4.0 DESIGN DEVELOPMENT

4.9 RESPONSE TO PLANNING FEEDBACK

HOPWOOD HALL COLLEGE, MIDDLETON CAMPUS, ROCHDALE ROAD, MIDDLETON, M24 6XH
Application Nos 24/00548/LBC & 24/00547/FUL

CONSERVATION CONSULTATION RESPONSE		
Conservation Officer	Catherine Fenghour	
Date	2 August 2024	
Application Reference	24/00547/FUL and 24/00548/LBC	
Address	Hopwood Hall College, Rochdale Road, Middleton, M24 6XH	
Proposal	Conversion of former chapel to provide education/teaching facility including internal and external repairs and internal works to provide classrooms and associated facilities, alongside external landscaping and the addition of one accessible parking space

PROPOSED PLAN

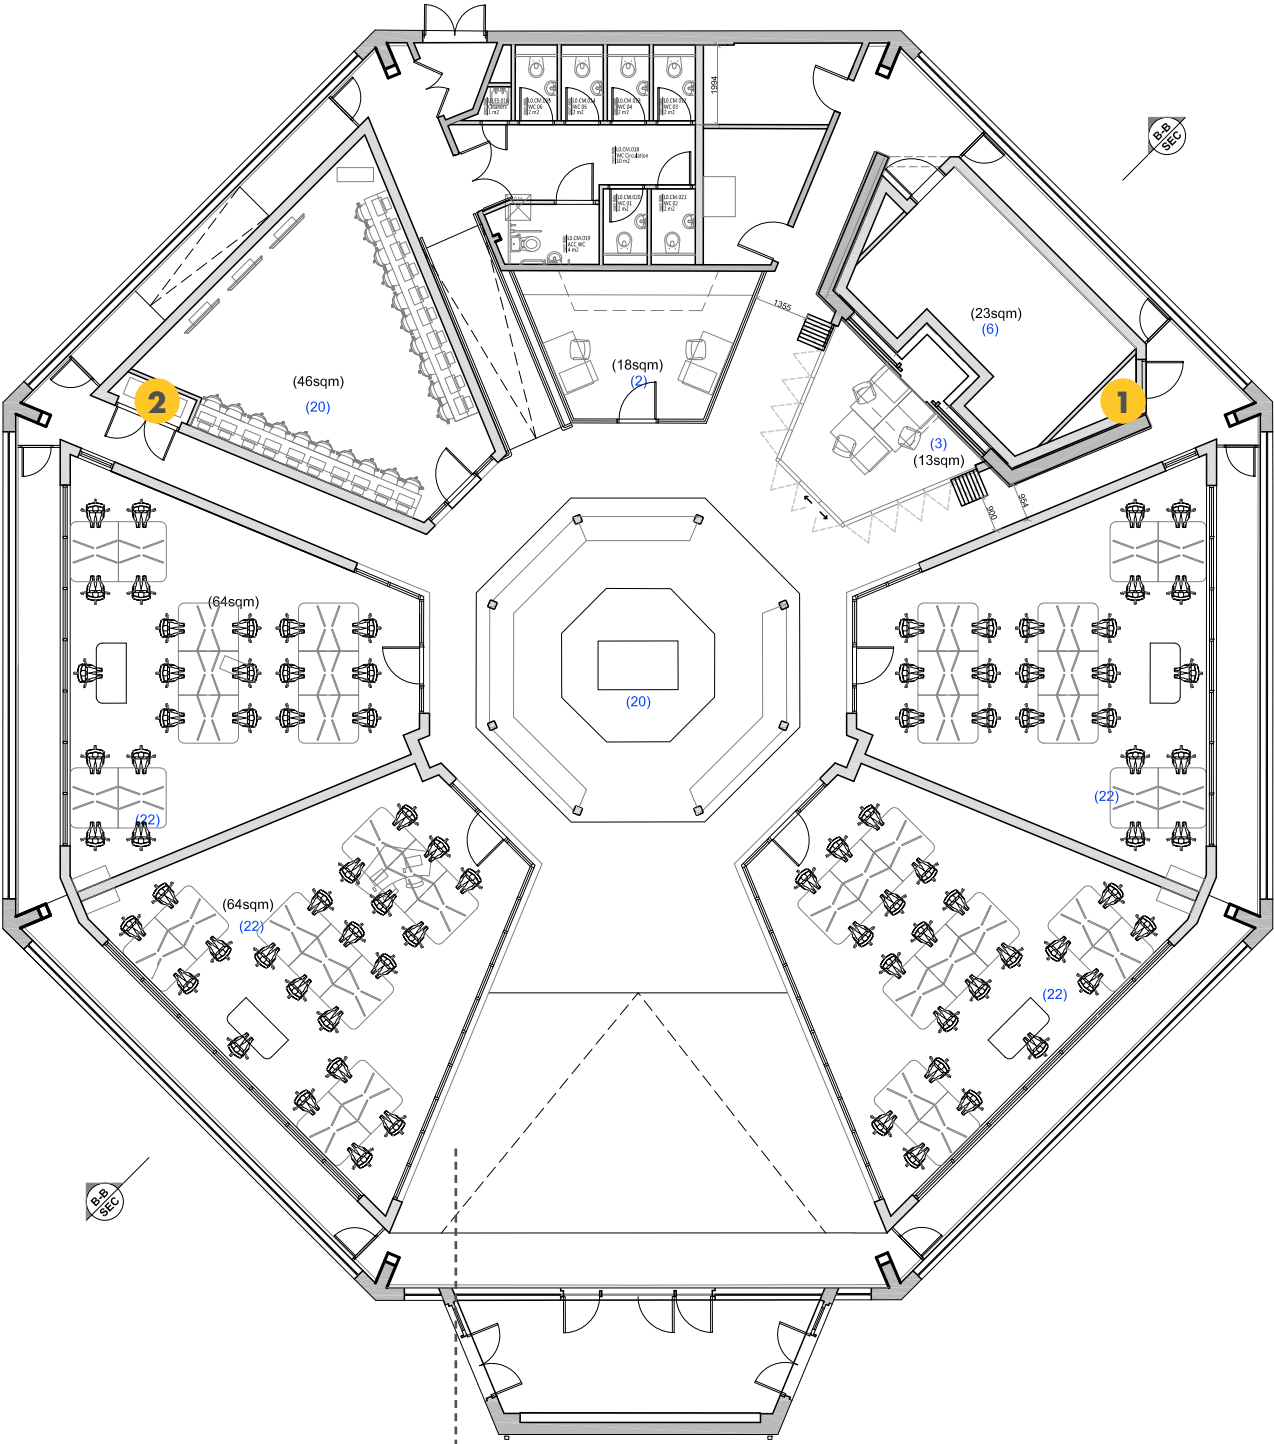
We would encourage the removal or reduction in size of classroom pods to either side of the main entrance to the chapel, to give a greater impression of the volume of the space and to prevent the sanctuary from becoming enclosed. The use of high-quality materials and finishes, with design drawing on the geometric shapes will be vital in sustaining the significance of the listed building.

Consideration has been given to the removal of the two pods to either side of the entrance as requested.

The new stores proposed adjoining the classroom pods either side of the entrance have been shown as re-positioned to help to open up the space as much as possible upon entering the Chapel.

- 1 Cleaner Store relocated
- 2 Laptop Store relocated

Stores re-positioned to increase sense of space upon entering the Chapel

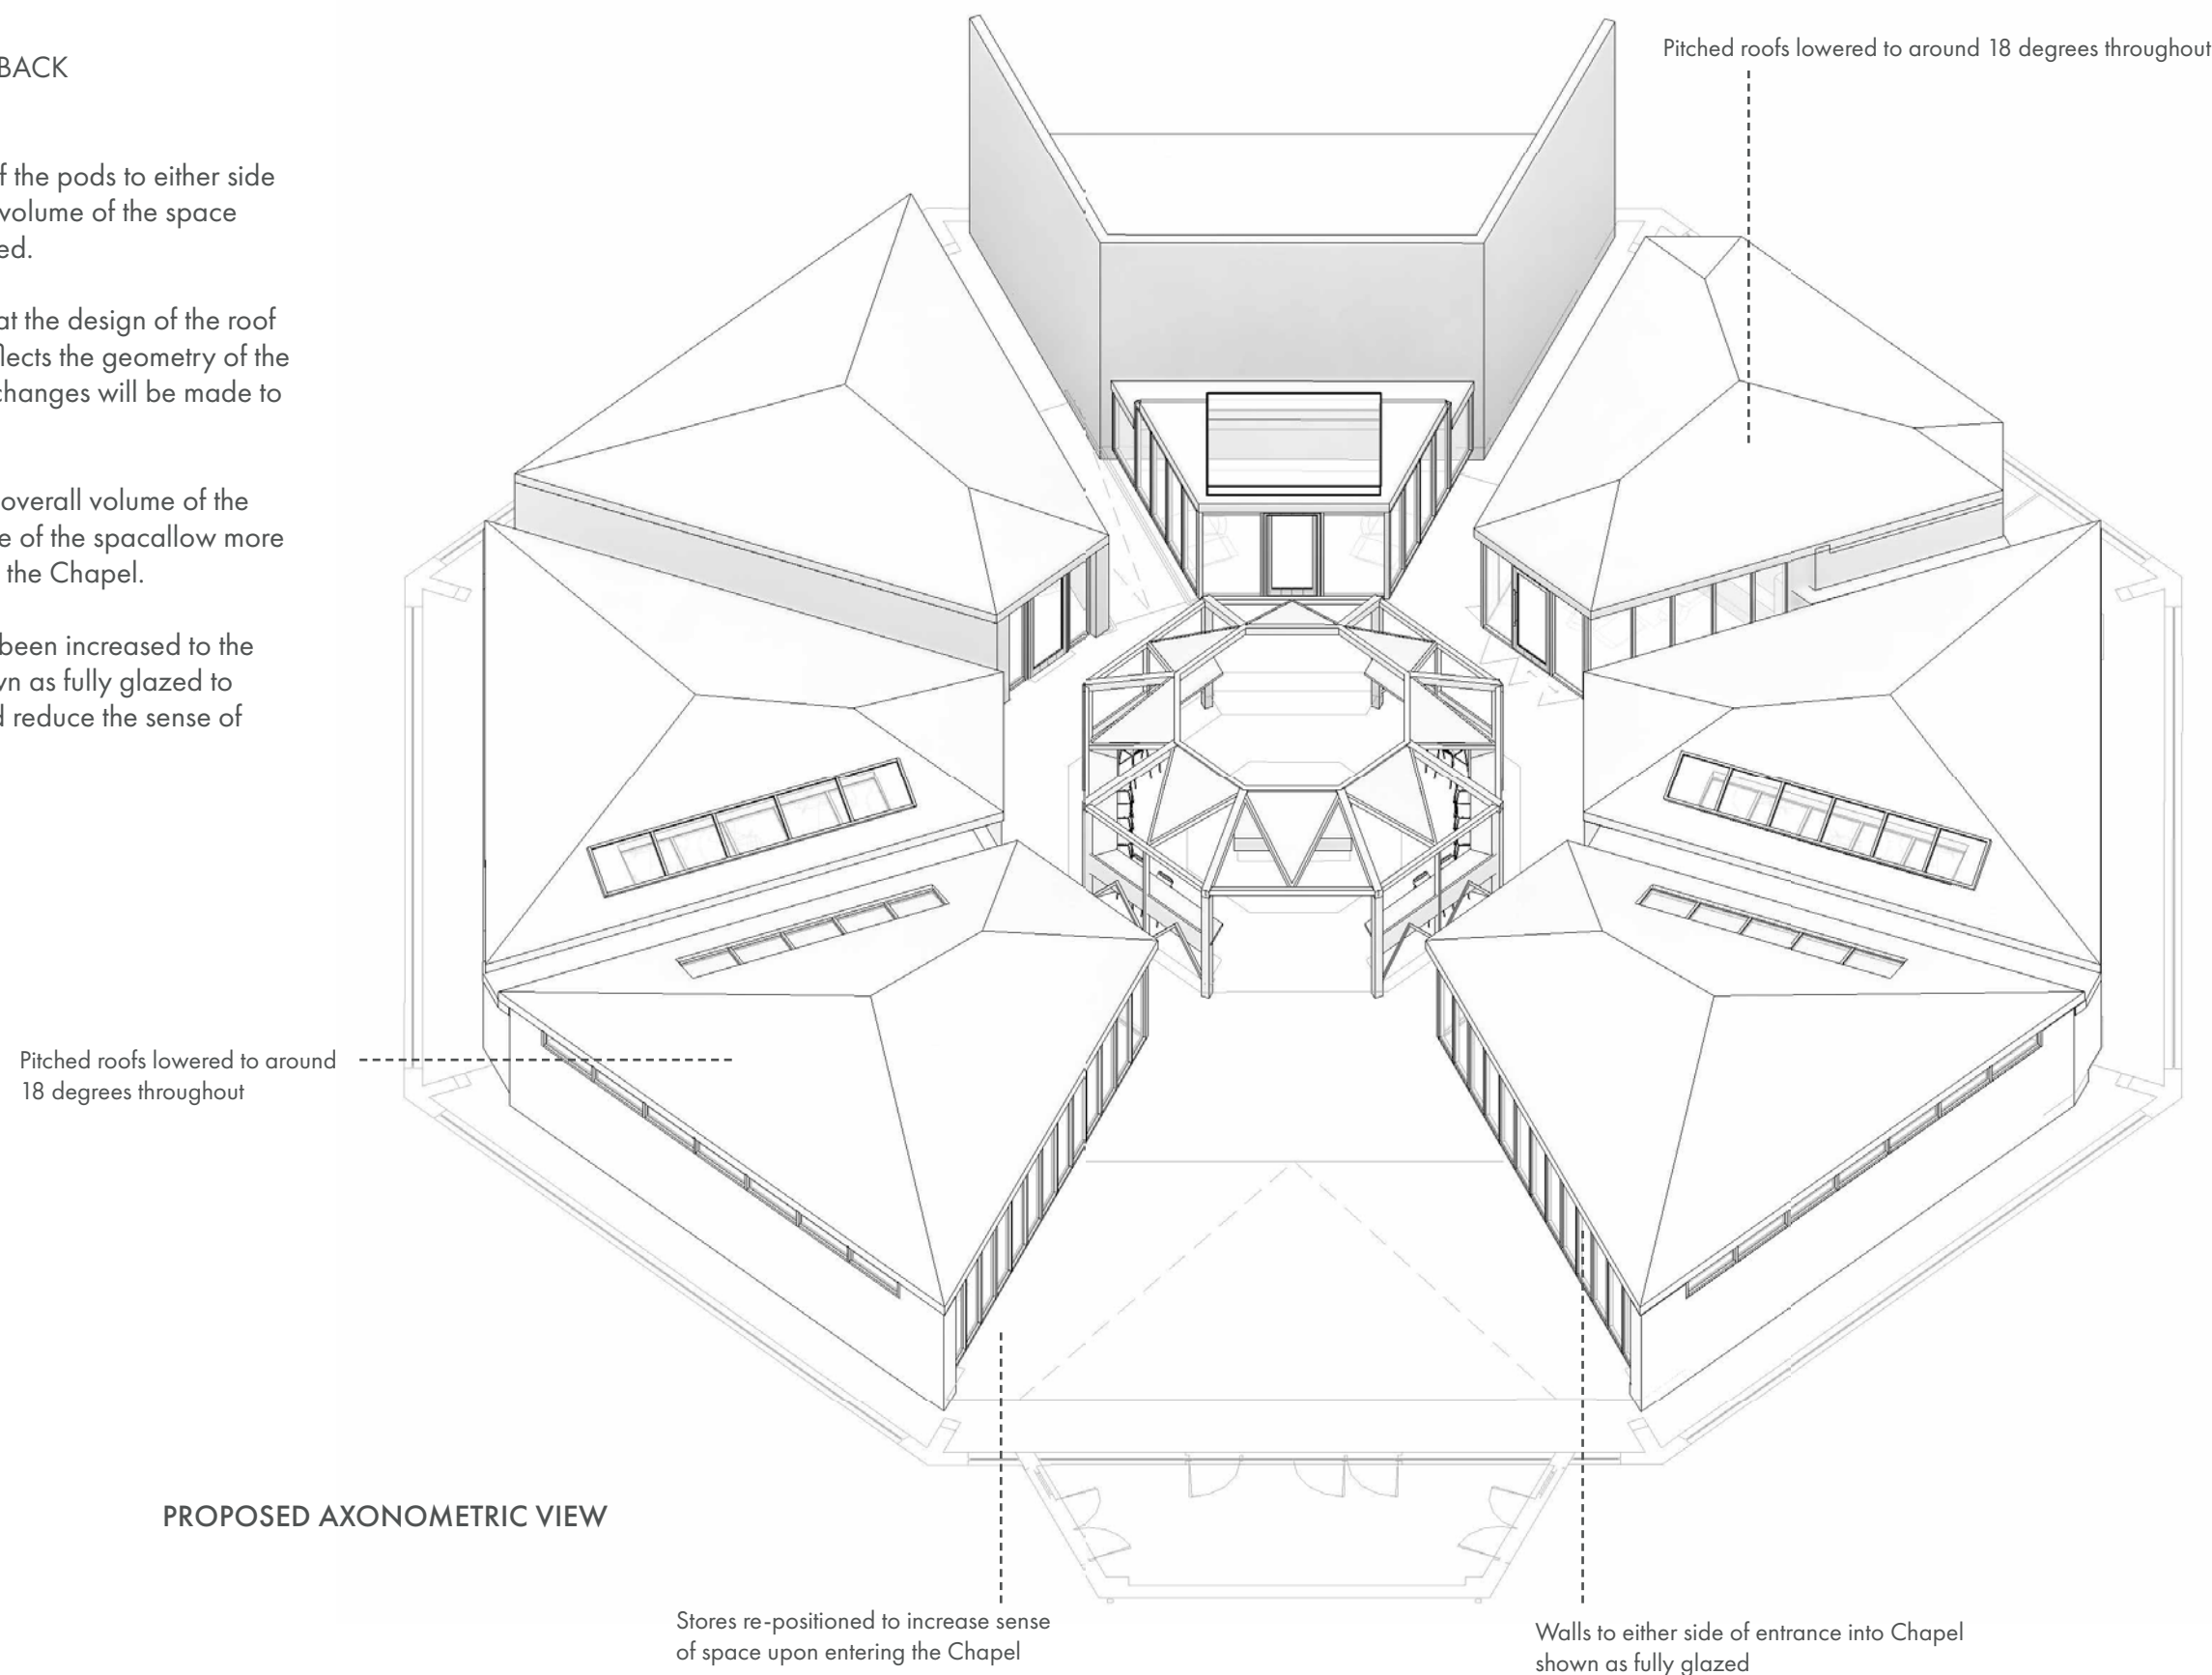
Further consideration has been given to the design of the pods to either side of the entrance, to allow a greater impression of the volume of the space and to prevent the sanctuary from feeling too enclosed.

Having considered several options, it is proposed that the design of the roof remains as a pitched roof system in order that this reflects the geometry of the existing roofscape. It is proposed that the following changes will be made to the design of the pods:

1. The pitch of the roof is reduced to help reduce the overall volume of the pods and to allow a greater impression of the volume of the space allow more of the original fabric to be visible upon entrance into the Chapel.
2. The amount of glazing to the classrooms has also been increased to the walls either side of the entrance. These are now shown as fully glazed to help increase the visual permeability of the pods and reduce the sense of enclosure upon entrance into the Chapel.

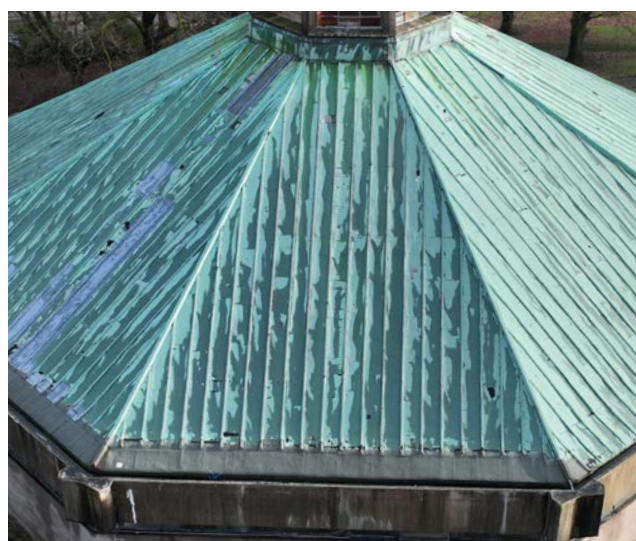
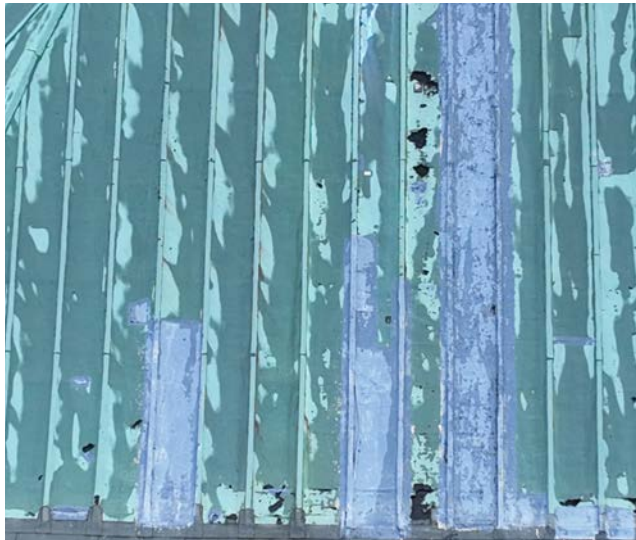
- The roofing and cladding works – more information /justification is needed if wholesale replacement continues to be proposed
- Historic England have raised concerns with the pods at the entrance. These comments need to be taken on board and either the plans amended or further justification provided.

Our preference from a heritage and cost perspective would be to retain and repair the existing copper roof and cladding. However, it is proposed to replace the existing copper roof covering as this is considered to be beyond economic repair.

Advice has been sought from two independent roofing contractors with experience of working with copper roofing. Their comments have been summarised below:

Consideration has been given to the retention of the existing copper and overlaying this using a new copper roof in order that the historic fabric is preserved. However, it is felt that the retention of the copper in it's current condition could potentially cover up ongoing issues with moisture ingress which would be detrimental to the building fabric going forwards.

A series of images are included opposite which illustrate the current condition of the roof, taken from Drone Survey footage in January 2024.

PROPOSED AXONOMETRIC VIEW

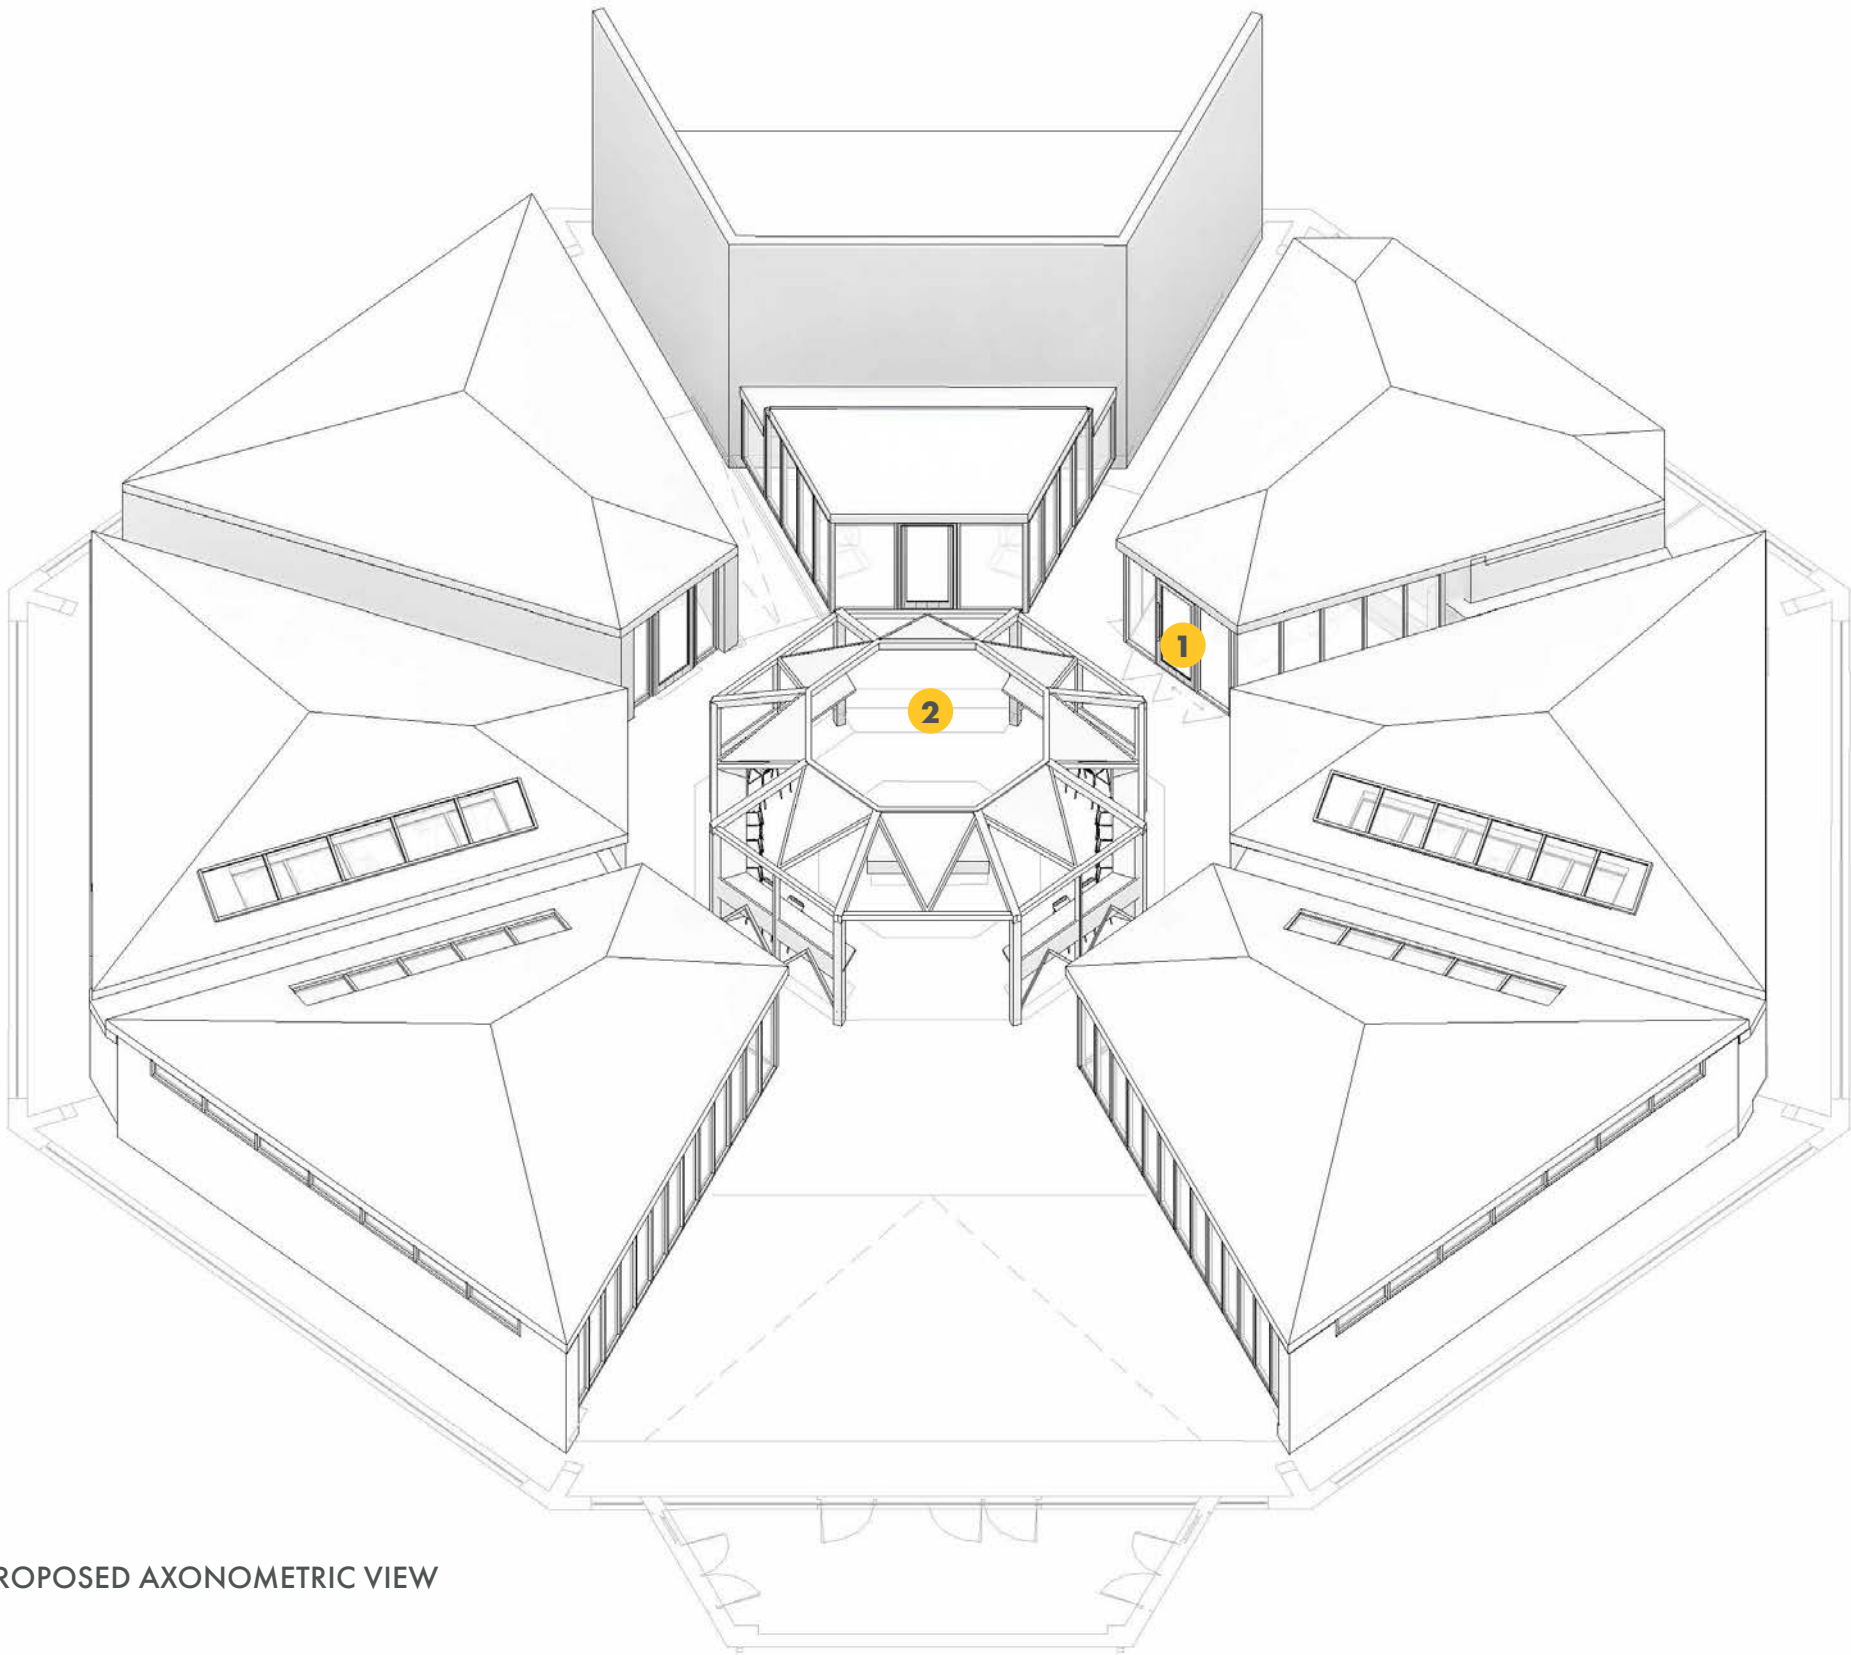
We do however have concerns about proposals to enclose the Blessed Sacrament chapel to create an immersive VR space and staff office. We feel that this chapel should be left unenclosed and remain

visible from the centre. The section of the new canopy around the altar could be opened up to that side too. This would allow the interesting existing canopy feature over the Blessed Sacrament altar to appear in its intended relationship with the main altar.

It is therefore proposed that this pod is retained but that the design is amended to increase views towards the Blessed Sacrament Chapel and to help preserve the relationship between this and the central altar. The following amendments are proposed:

1. Glazed walls to the office pod are amended to bi-folding doors system to allow these to be fully opened up to minimise the enclosure of the altar and canopy.
2. Sanctuary area amended to re-position the entrance into the Sanctuary area to sit opposite the side chapel - helping to reinforce the historic relationship between the central Altar and the Blessed Sacrament Chapel.

- 1 Bi-folding doors to Office to reduce the sense of enclosure to the Blessed Sacrament Chapel
- 2 Amendments to Sanctuary area to reinforce the relationship between the central altar and the Blessed Sacrament Chapel
